IMU

Connect_Main_Control_Board

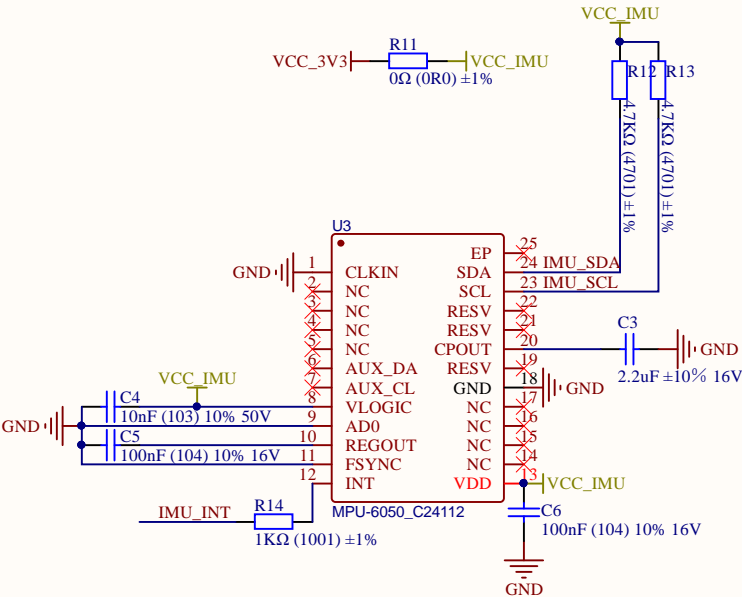
IMU布局需要挖槽，避免应力
